ADDENDUM #2

Reference: Technology Building Classroom Remodel Level 4
Salt Lake Community College
DFCM Project No. 06057660

ADDENDUM NO. 2

Technology Building Classroom Remodel Level 4
Salt Lake Community College
4600 South Redwood Road
Taylorsville, Utah
DFCM Project No. 06057660

SECTION BETWEEN FLOORS

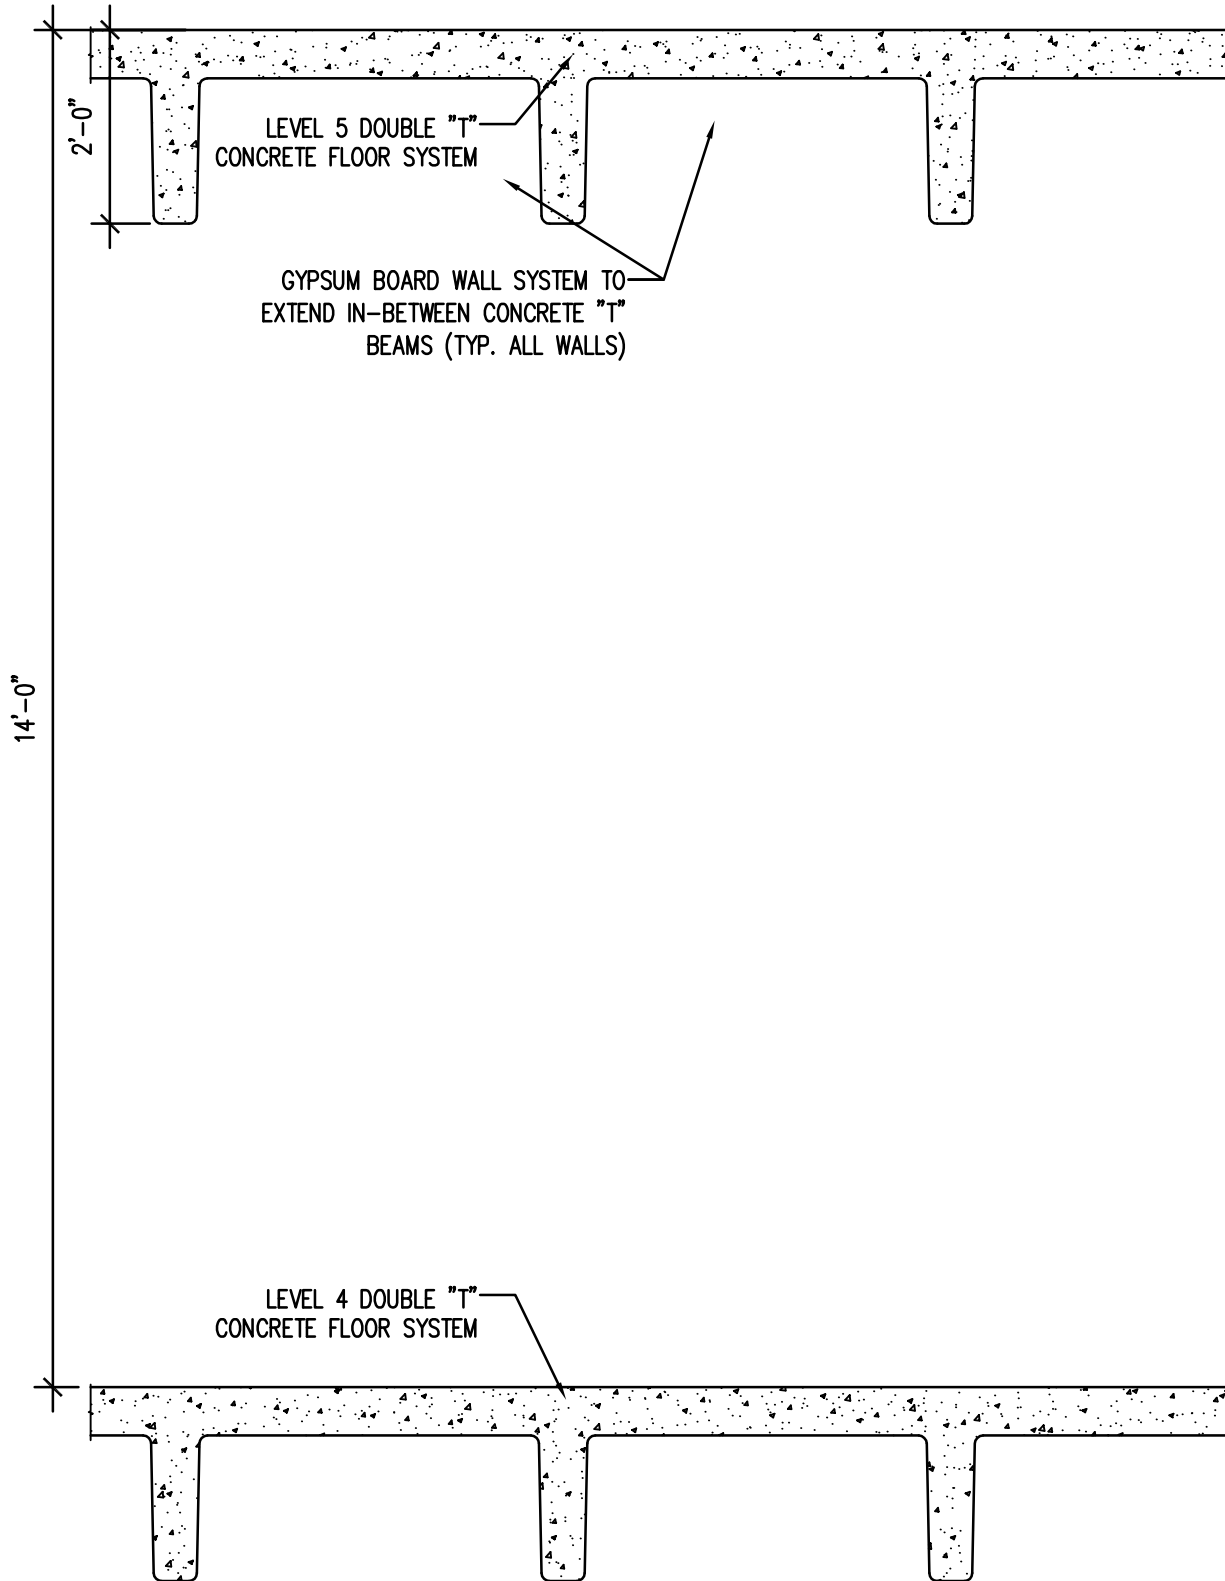
2. General contractor shall note that the distance from existing concrete floor slab located on level 4 to the top of concrete floor slab on level 5 is 14'-0". The existing floor slab on level 5 consists of double "T" concrete beams that are 2'-0" deep. The general contractor shall note that the new gypsum board walls dividing classroom spaces will need to extend between the webs of the double "T" concrete beam system. See attached addendum drawing 01/AD02 for further clarification.
